2023 SWITCHGEAR UPGRADE RECORD DRAWINGS REDLINED FOR 2025 CHANGES	
W–058508–01A	PHYSICAL LAYOUT
W–058508–01B	BASE & SECTIONAL VIEW
W–058508–02	SINGLE LINE DIAGRAM
W–058508–03	NAMEPLATE DETAILS
W–058508–04A	GENERATOR 1 AC SCHEMATIC
W–058508–04B	GENERATOR 2 AC SCHEMATIC
W–058508–04C	GENERATOR 3 AC SCHEMATIC
W–058508–05A	FEEDER BREAKER/MASTER AC SCHEMATIC
W–058508–05B	FEEDER BREAKER/MASTER AC SCHEMATIC
W–058508–05C	VFD AC SCHEMATIC
W–058508–06A	GENERATOR 1 DC CONTROL SCHEMATIC
W–058508–06B	GENERATOR 2 DC CONTROL SCHEMATIC
W–058508–06C	GENERATOR 3 DC CONTROL SCHEMATIC
W–058508–07A	GENERATOR 1 DC CONTROL SCHEMATIC
W–058508–07B	GENERATOR 2 DC CONTROL SCHEMATIC
W–058508–07C	GENERATOR 3 DC CONTROL SCHEMATIC
W–058508–08A	GENERATOR 1 DC CONTROL SCHEMATIC
W–058508–08B	GENERATOR 2 DC CONTROL SCHEMATIC
W–058508–08C	GENERATOR 3 DC CONTROL SCHEMATIC
W–058508–09	MASTER DC CONTROL SCHEMATIC
W–058508–10	MASTER DC CONTROL SCHEMATIC

**KWETHLUK M&I 2025
IMPROVEMENTS PROJECT
ISSUED FOR CONSTRUCTION
MAY 2025**

ALASKA ENERGY AUTHORITY		
PROJECT: KWETHLUK M&I 2025 IMPROVEMENTS		
TITLE: SCHEDULE OF DRAWINGS		
 P.O. 111405, Anchorage, AK 99511 (907)349-0100	DRAWN BY: BCG	SCALE: NO SCALE
	DESIGNED BY: BCG	D

CUSTOMER ALASKA ENERGY AUTHORITY			
CUSTOMER JOB No. 21116			
DRAWN BY JRV	AUTH BY JRP	DATE 02-15-23	REV 3
DRAWING/FILE No. W-058508-06C			SHEET 6C

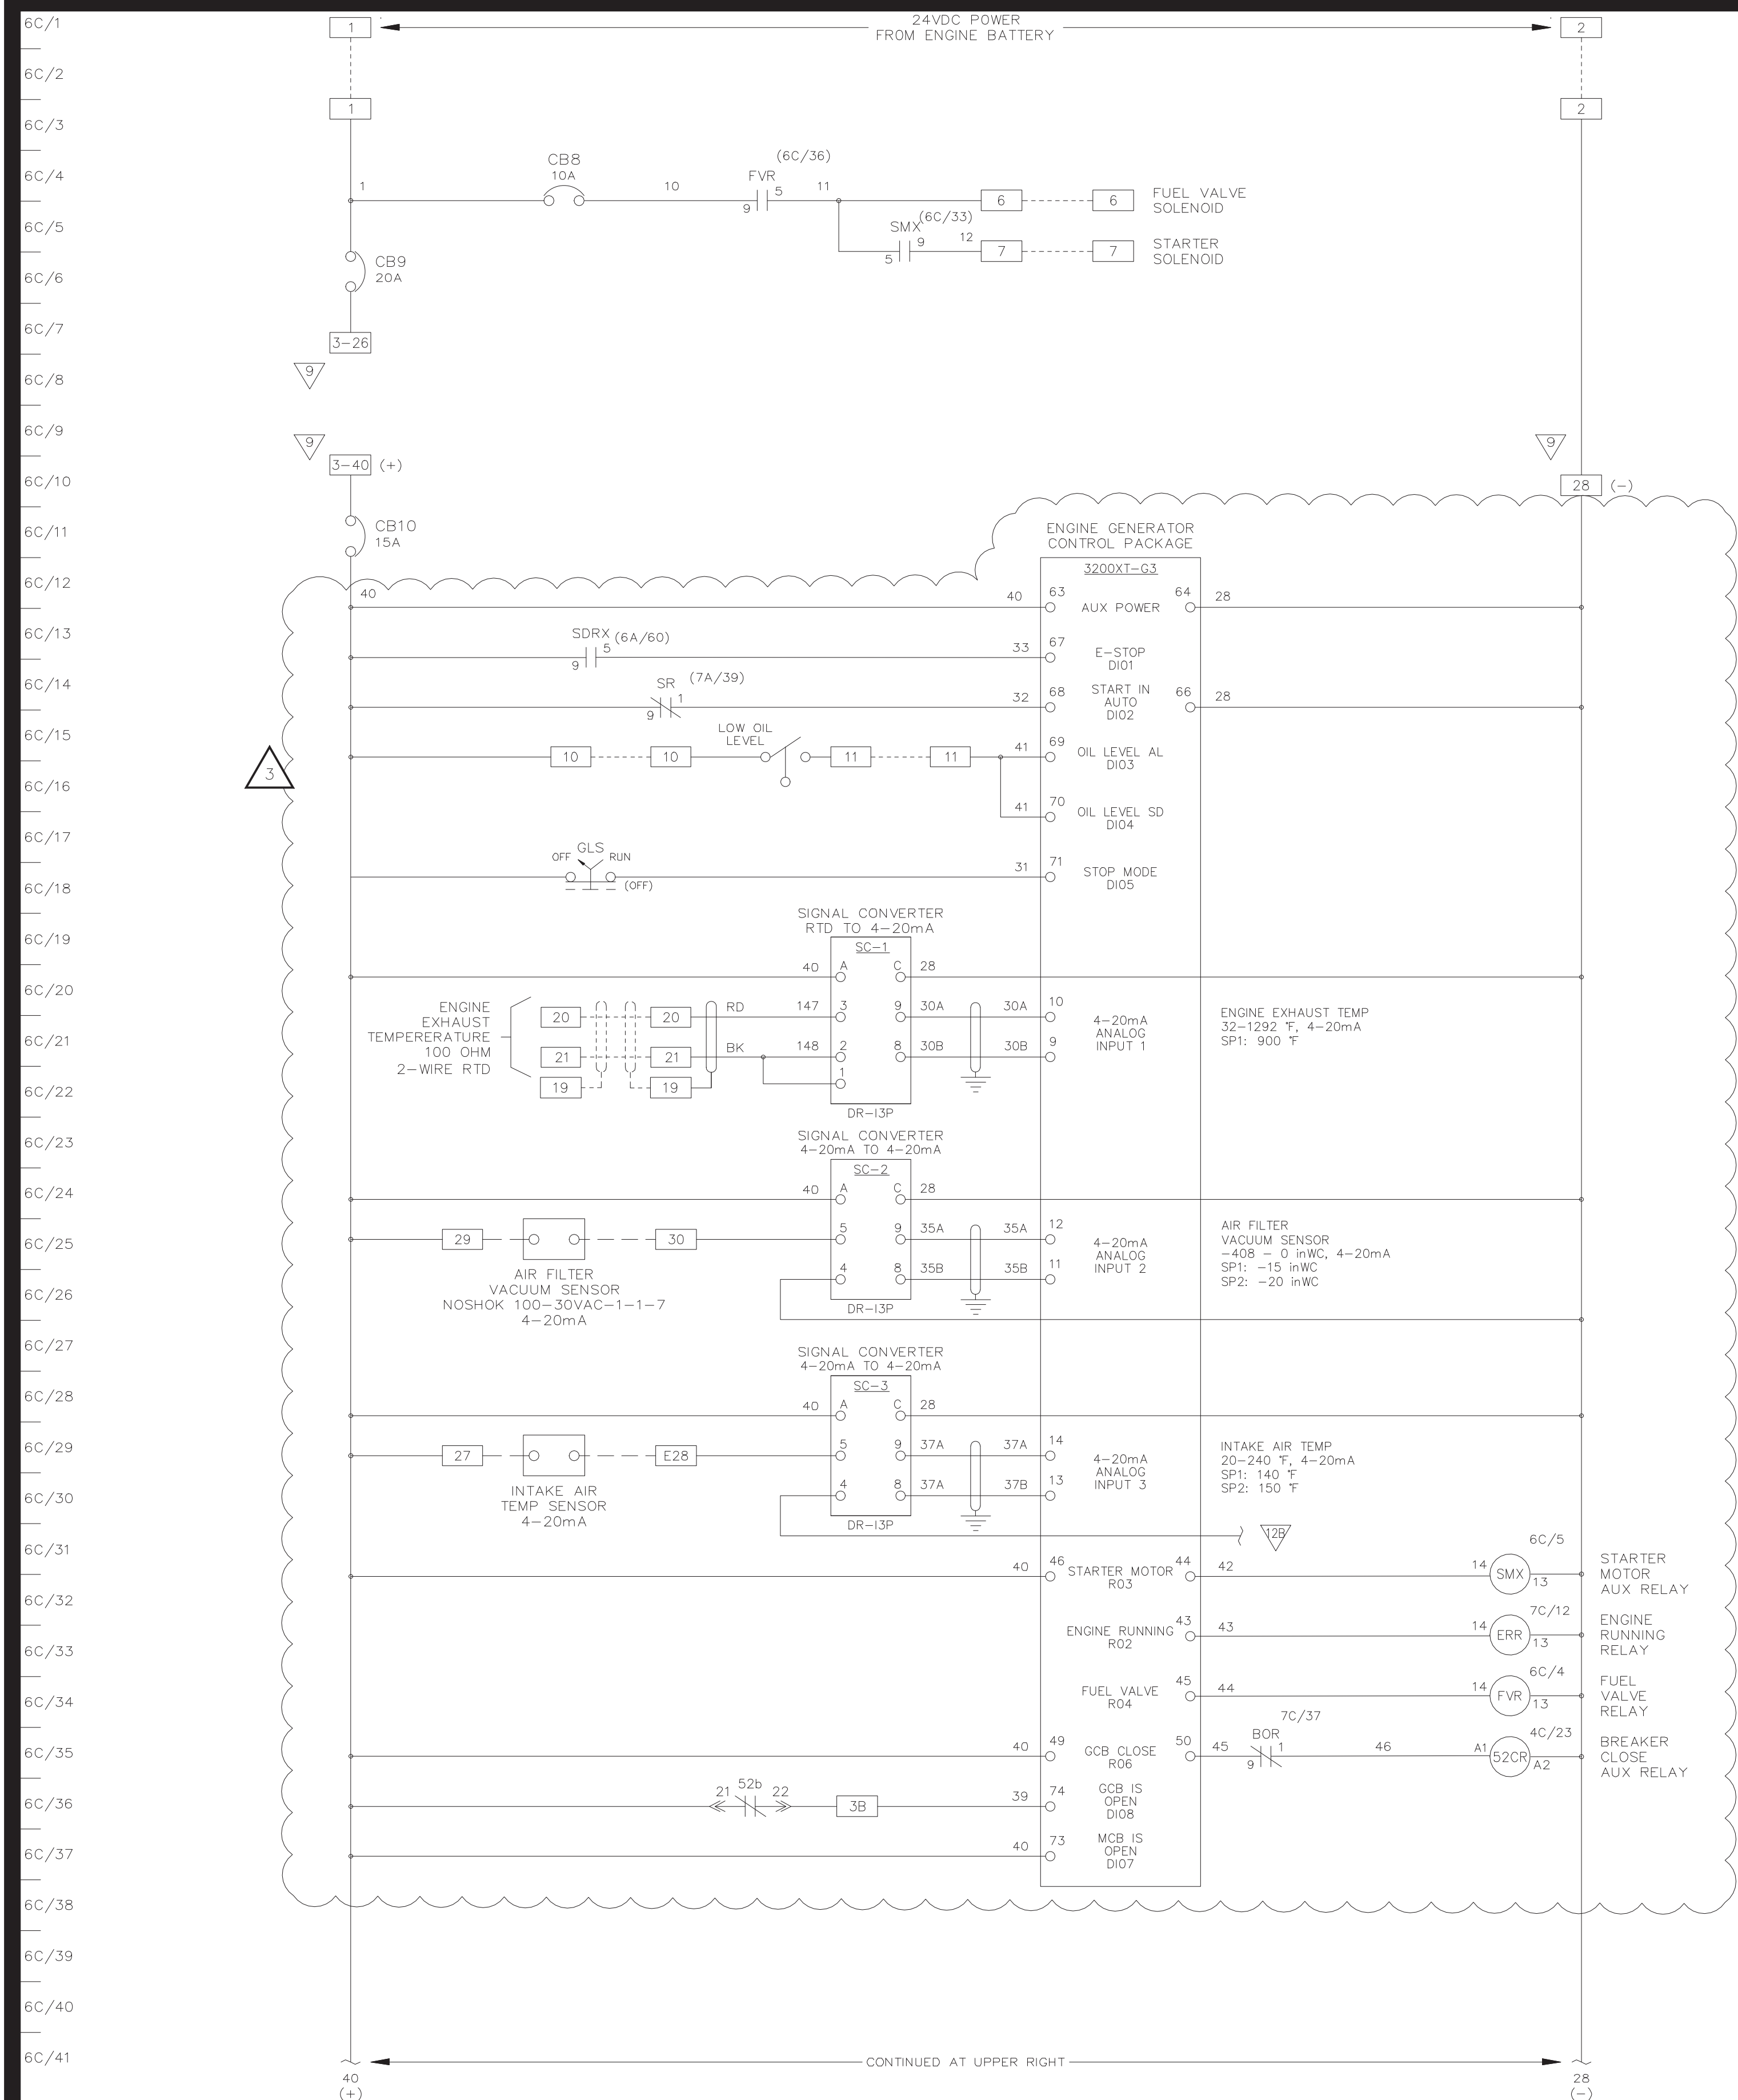
ADD XM500-G3 IN SWITCHGEAR,
ADD OIL PRESSURE SENSOR AND WATER
TEMPERATURE SENSOR AT GEN#3, AND
SHOW INTERCONNET WIRING IDENTICAL TO
GEN#1 & GEN#2. SEE SHEET E6.6.
